**METROPOLITAN DEVELOPMENT COMMISSION
HEARING EXAMINER**

Case Number: 2025-ZON-062 (Amended) / 2025-VAR-007

Property Address: 5709 Five Points Road and 7340 East Edgewood Avenue

Request: Variance of Development Standards of the of the Consolidated Zoning and Subdivision Ordinance to provide for reduced lot width of 68 feet and lot area of 8,500 square feet for duplexes (90-foot lot width and 10,000-square foot lot area required), 56% reduced open space (65% required), and to provide for three monument signs (maximum of two monument signs for each residential community permitted).

Site Plan – September 8, 2025

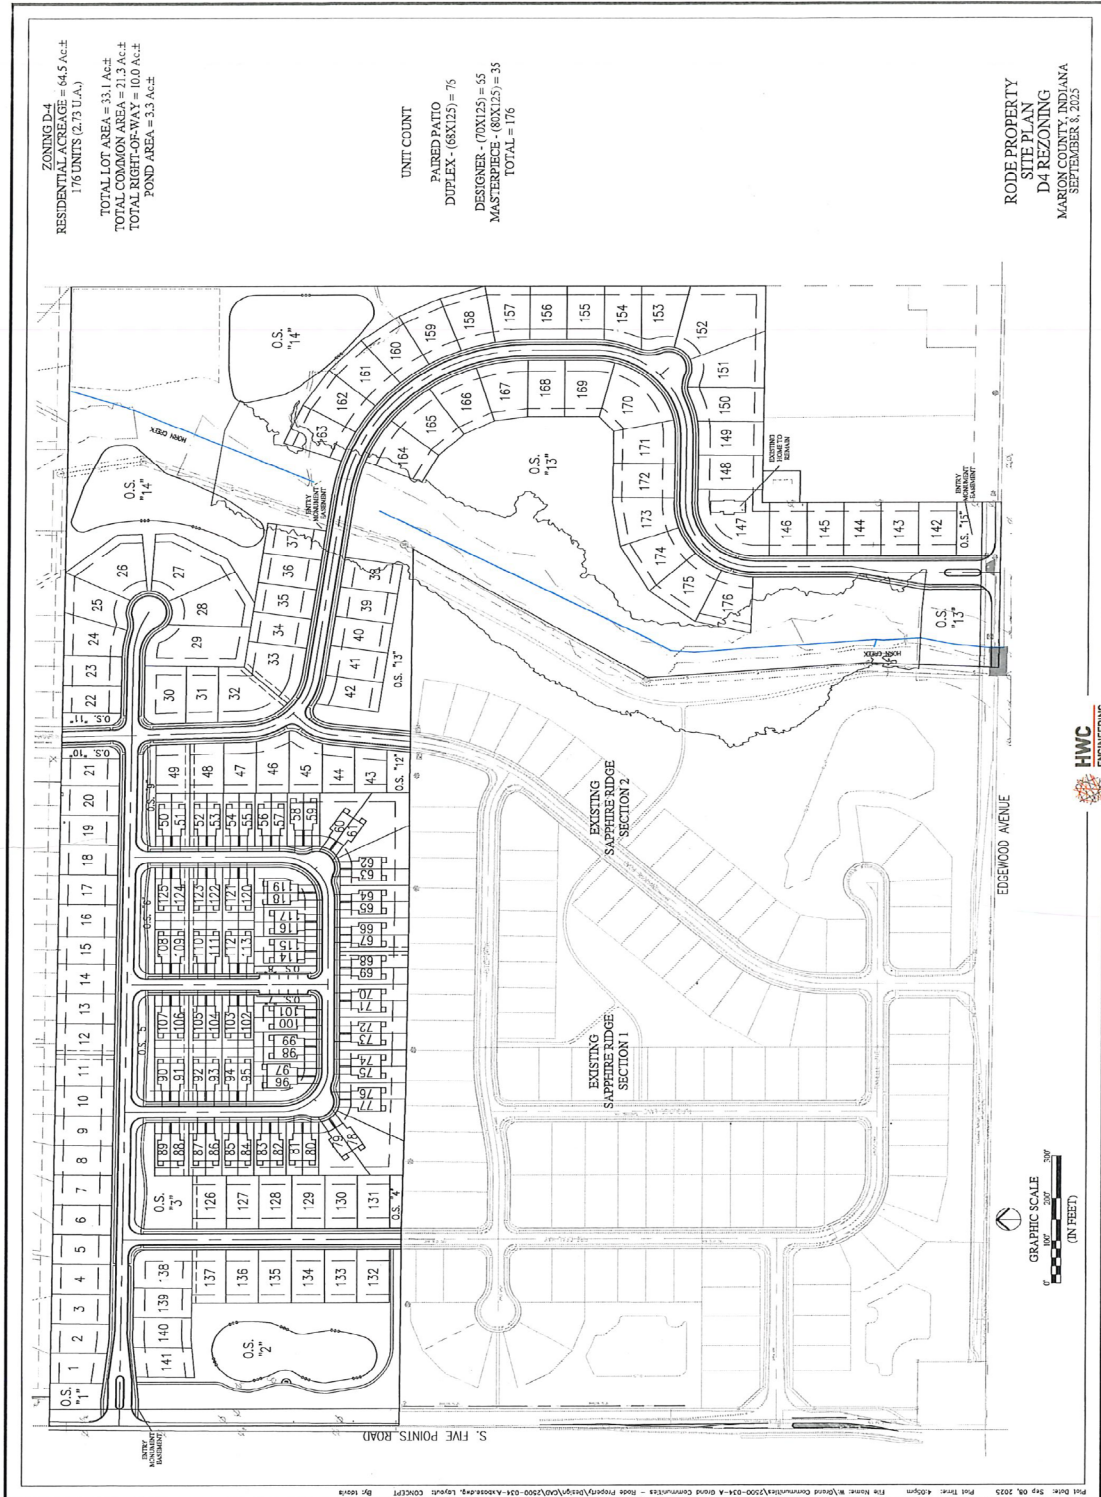
The site plan, file dated September 8, 2025, provides for 176 lots consisting of 100 single-family dwellings and 76 duplexes (paired patio homes).

Access would be from East Edgewood Avenue and Five Points Road, both of which would be boulevard entrances. One stub street along the northern boundary and two stub streets along the southern boundary would provide additional access connections to the subdivision to the north and south.

Staff would note that support of the rezoning request does not include approval of the site plan that would be required to go through the platting process.

Approval of these requests, subject to the following commitments being reduced to writing on the Commission's Exhibit "B" forms at least three days prior to the MDC hearing.

1. A 40-foot half right-of-way shall be dedicated along the frontage of Five Points Road and a 40-foot half right-of-way shall be dedicated along the frontage of East Edgewood Avenue, as per the request of the Department of Public Works (DPW), Engineering Division. Additional easements shall not be granted to third parties within the area to be dedicated as public right-of-way prior to the acceptance of all grants of right-of-way by the DPW. The right-of-way shall be granted within 60 days of approval and prior to the issuance of an Improvement Location Permit (ILP).

2. A southbound left-turn lane along Five Points Road at Entrance A shall be constructed in accordance with the recommendations of the TIS and the DPW.
